Staff Report

Date: March 28, 2022

To: Conservation Commission

Subject: **748 Sconticut Neck Road – Request for Certificate of Compliance – DEP# 023-0725, Fairhaven CON 023-204**

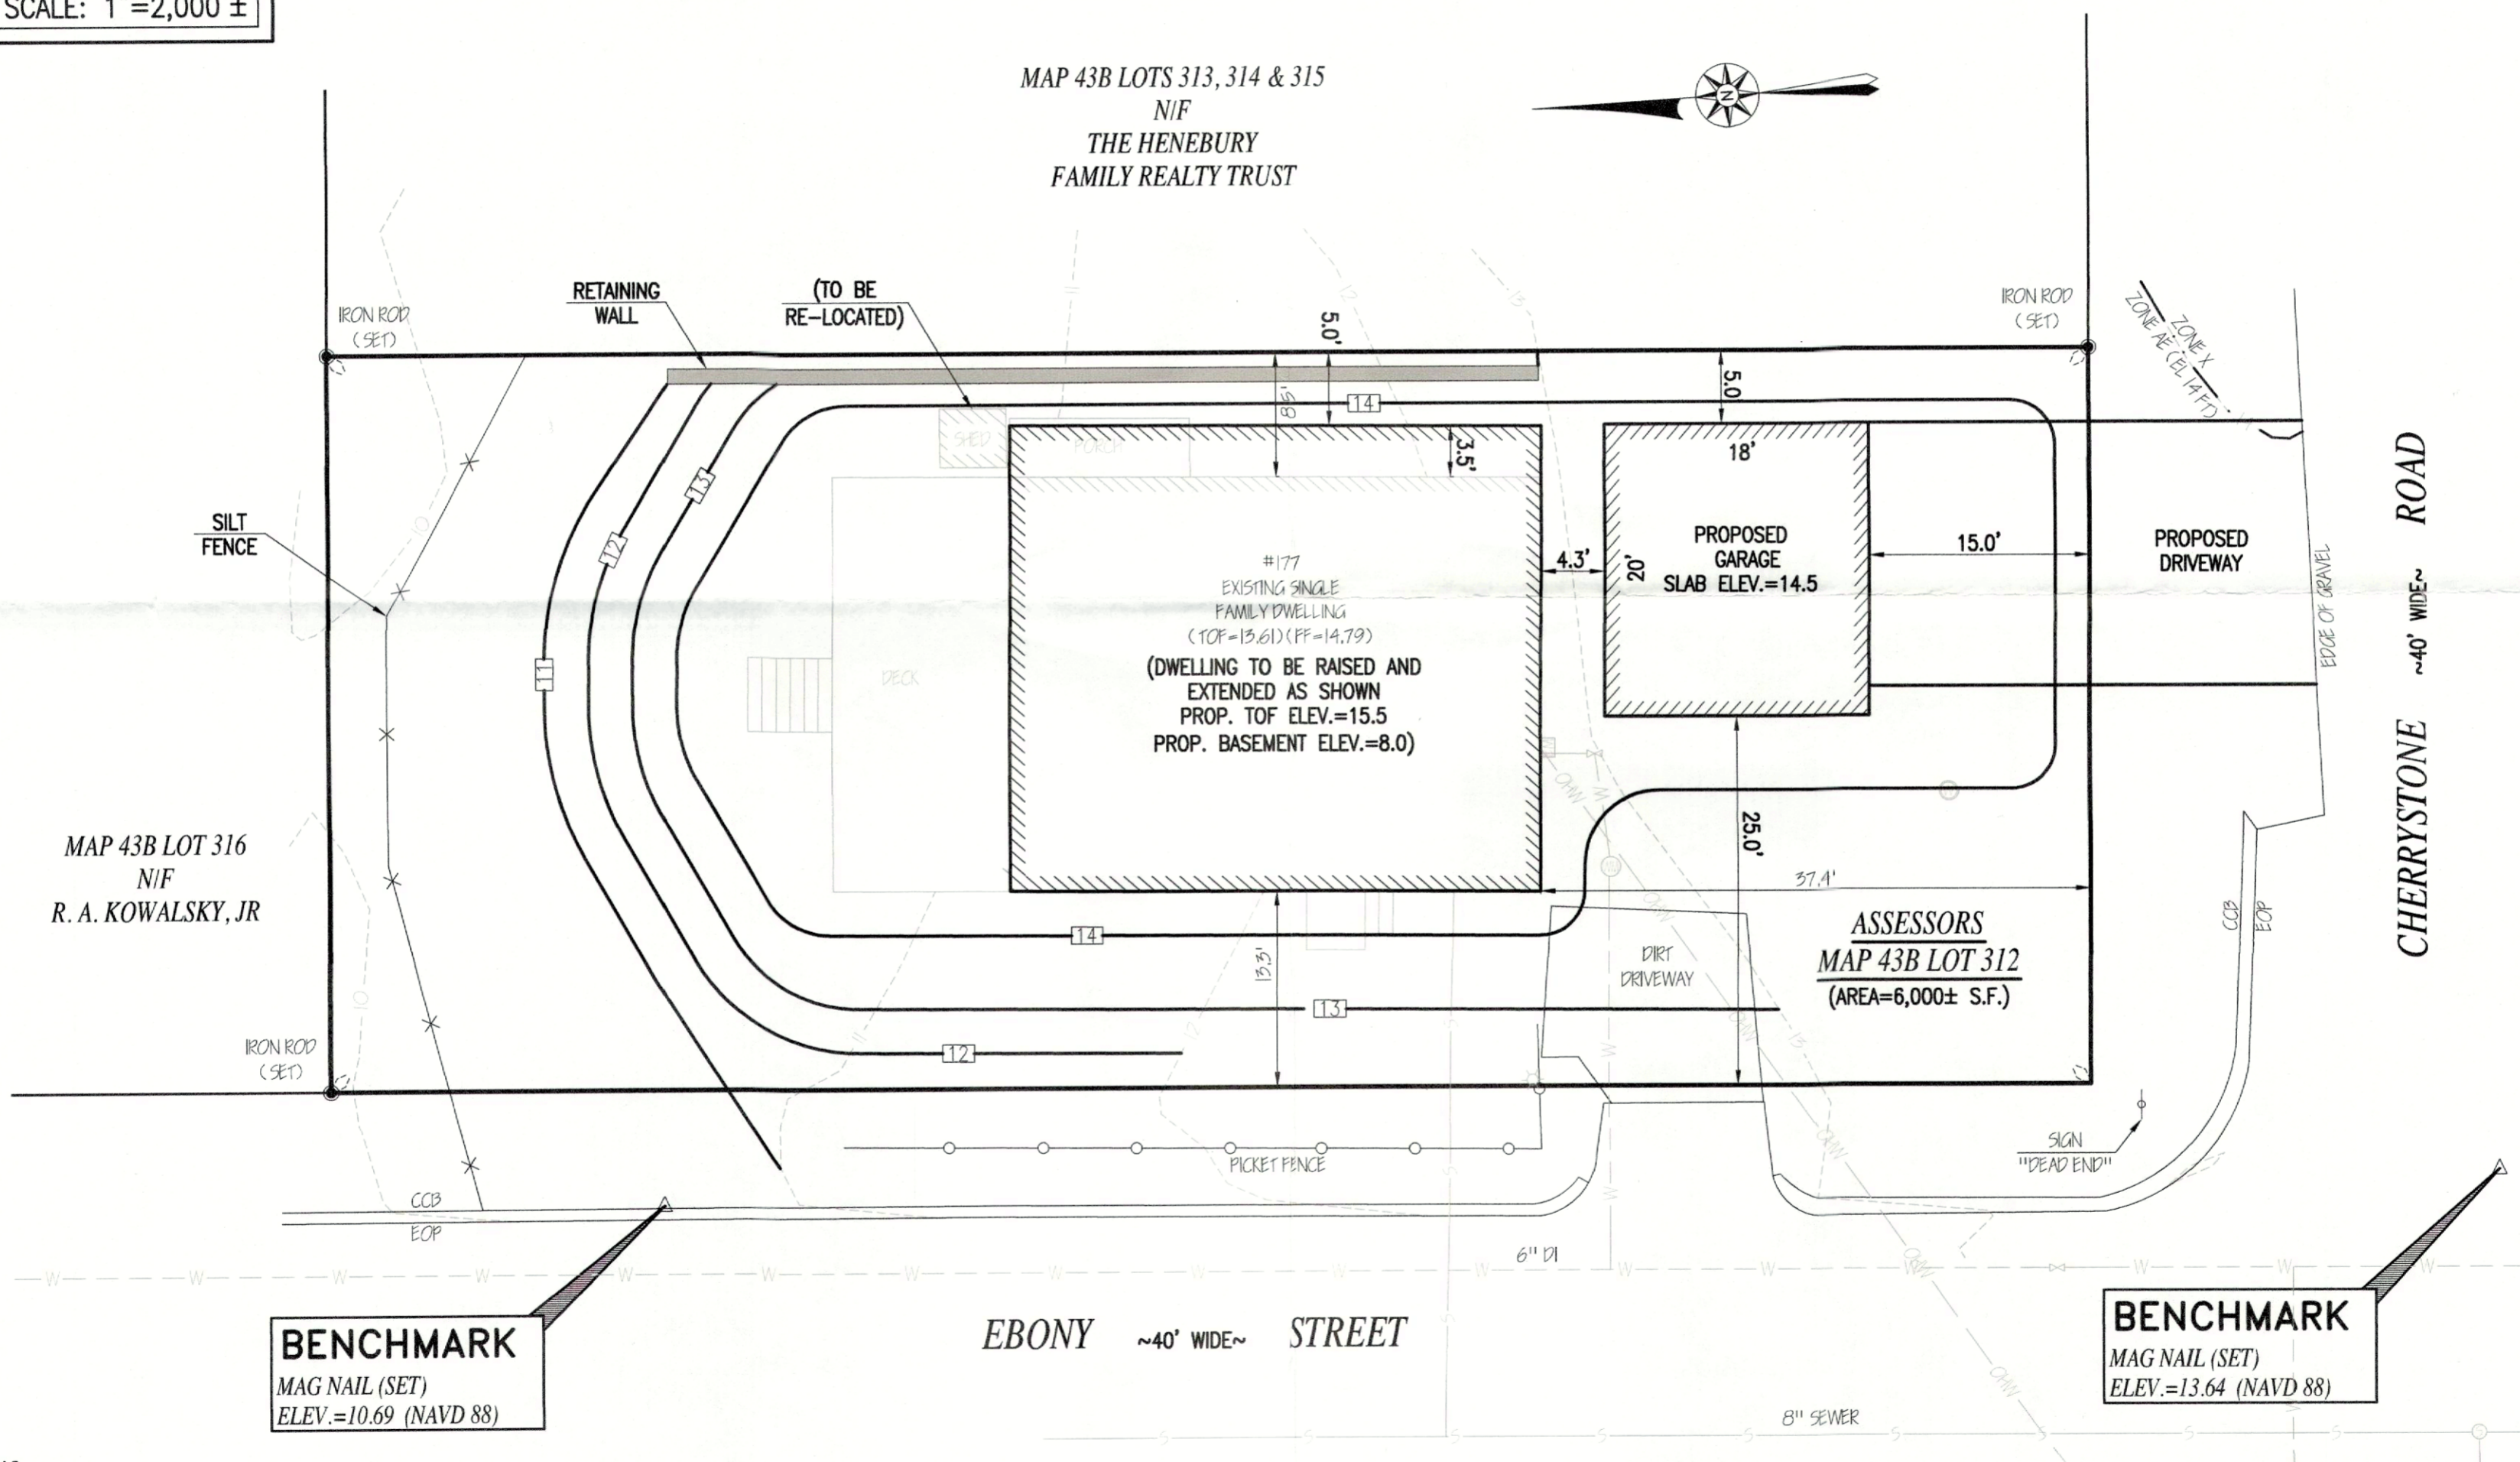
- The applicant’s representative submitted an affidavit noting that the project appears to have been constructed in substantial compliance with the approved plans. They noted the only deviation was that fill was not placed on site to raise the adjacent grade of the structure above floodplain elevation.
- A site visit confirmed that the fill was not placed. The garage has been constructed. The concrete driveway was installed larger than depicted on the plans, but it appears it was installed more than two years ago based on the aerial photographs.
- The property falls predominantly in the AE Flood zone with the southern portion in Zone X.
- Overall, it appears this project was constructed in substantial compliance with the Order of Conditions and approved plans. Not adding the fill decreases the likelihood that floodwaters would be redirected to adjacent properties.

- Fill was not placed on site to raise the adjacent grade of the structure above floodplain elevation.

EXISTING CONDITIONS PLAN
FOR
WASH ASHORE CAR WASH
FAIRHAVEN, MASSACHUSETTS 02719
JANUARY 21, 2022

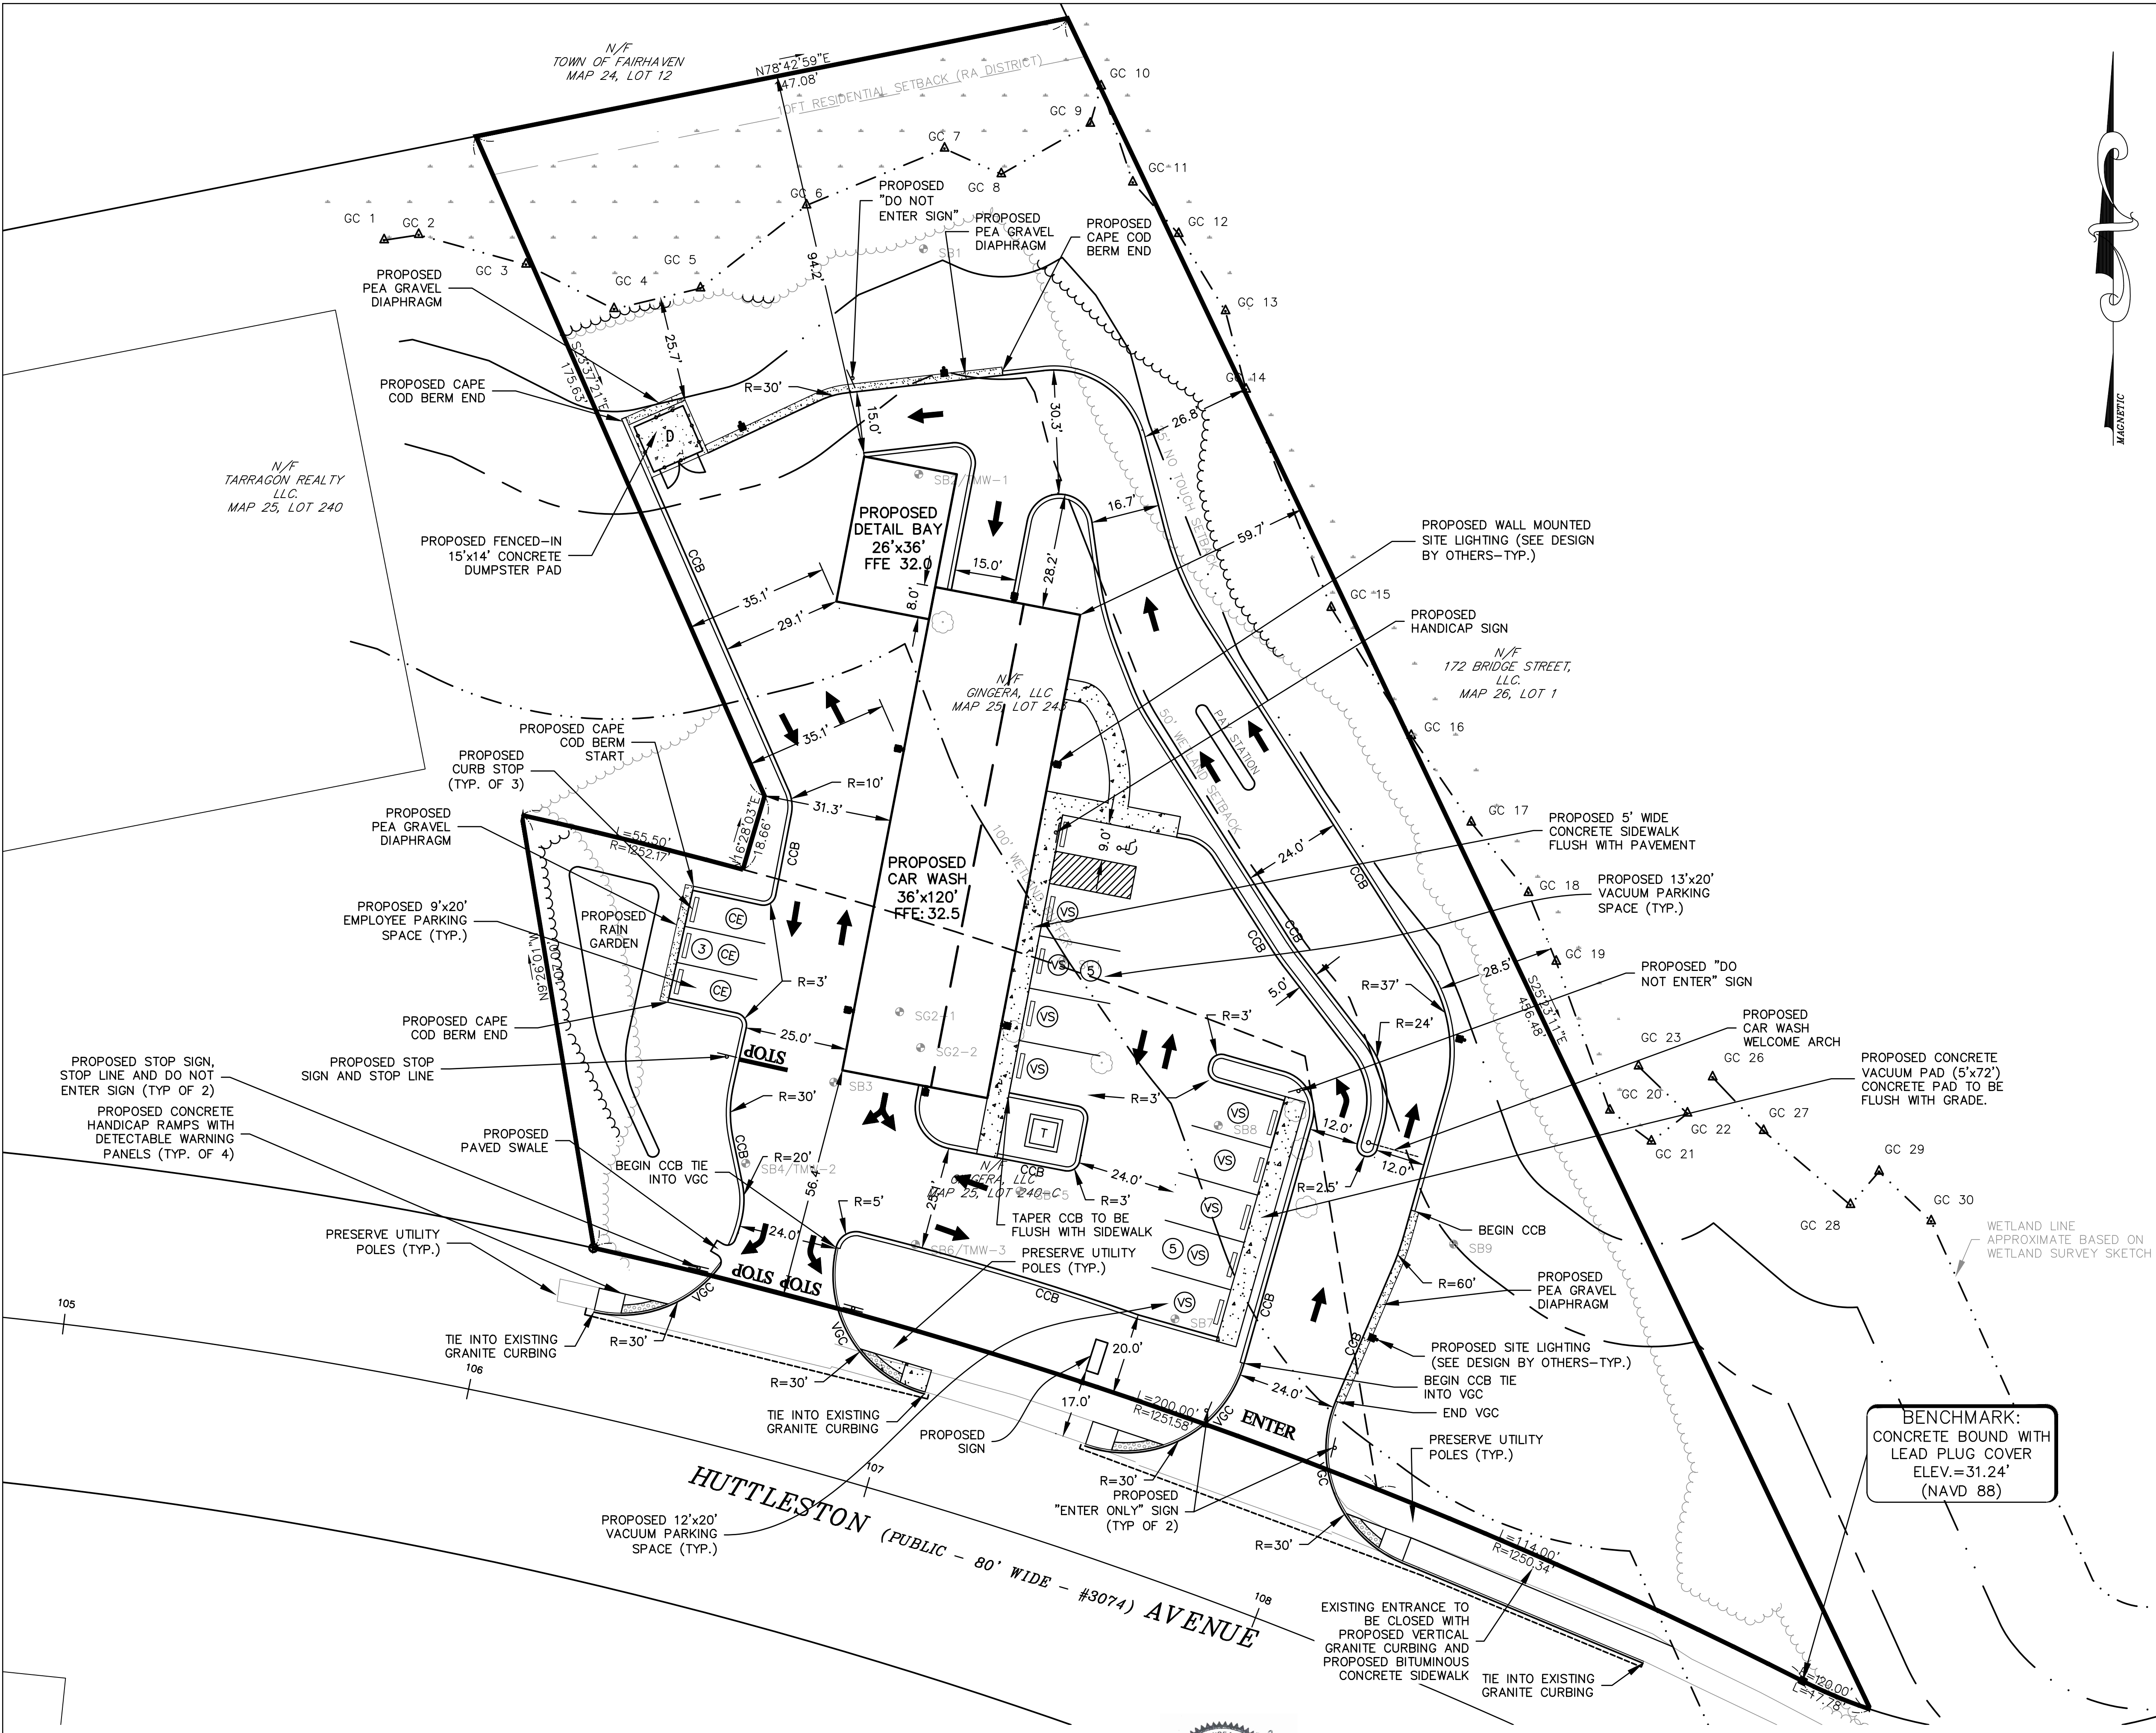
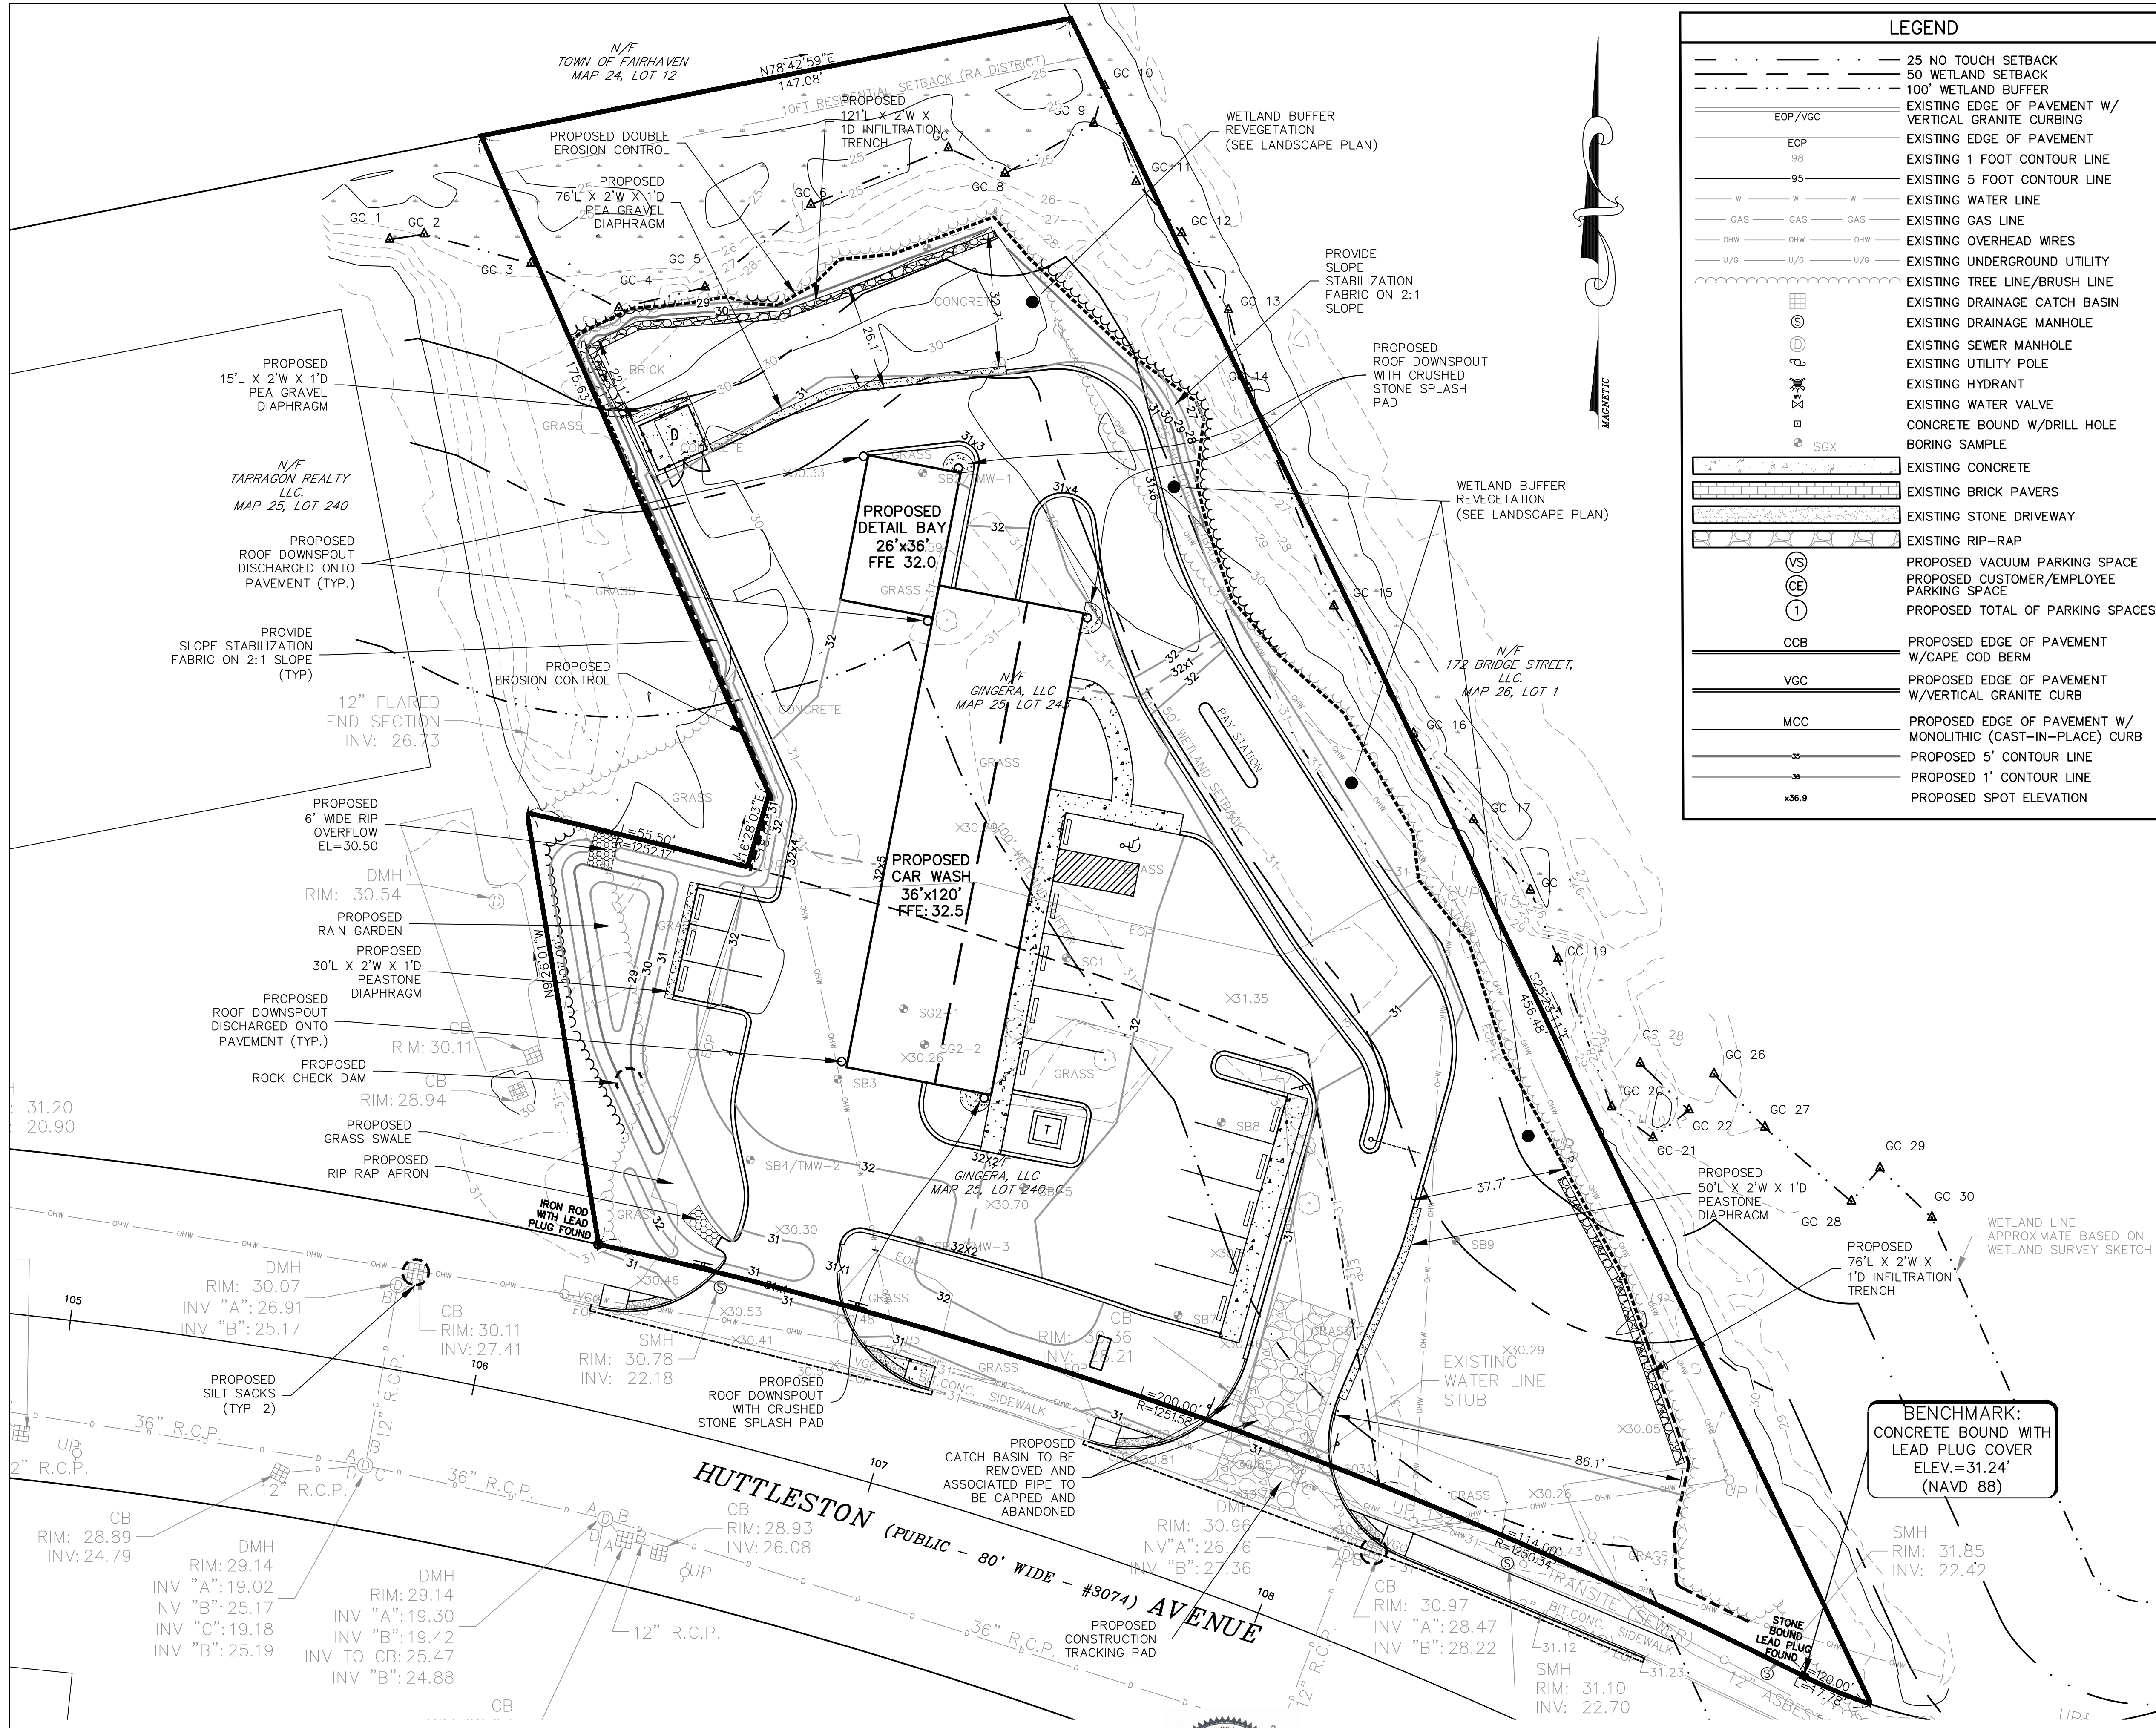
- Revised site plans have been submitted based on comments from Planning Board that result in a further reduction of impervious surfaces through the elimination of a parking space near Huttleston Avenue.
